## Proposal for Supplement 6 to the 06 series of amendments to Regulation No. 16 (Safety-belts)

The text reproduced below was prepared by the expert from CLEPA. The modifications to the current text of the Regulation are marked in bold or strikethrough characters

Figure 7

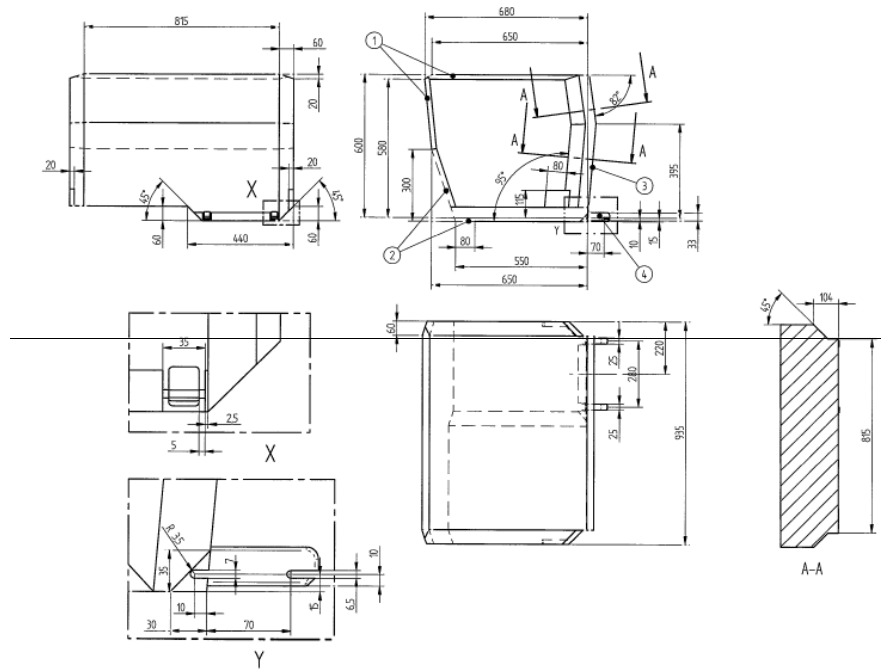
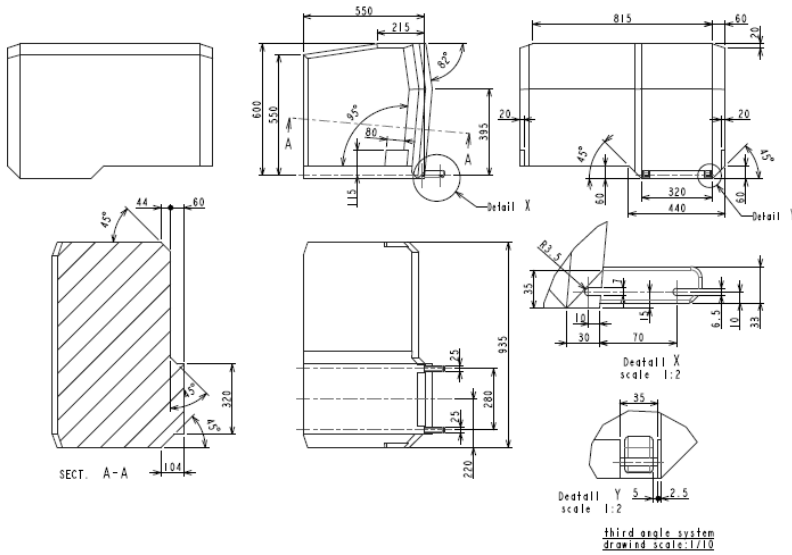
Paragraph 4.7., amend to read:

"4.7. Lateral facing child restraint systems envelope

**Envelope dimensions for lateral facing position CRS – ISO/ L1- ISOFIX SIZE CLASS F  
or symmetrically opposite – ISO/ L2 – ISOFIX CLASS G**

- 1 Limits in the rearward and upwards directions
- 2 Dashed line marks area where a support leg, or similar, of a specific vehicle CRS is allowed to protrude.
- 3 The backwards limitation (to the right in the figure) is given by the forward-facing envelope in Figure 2
- 4 Further specifications of the connector area are given in ISO 13216-1, Figures 2 and 3.
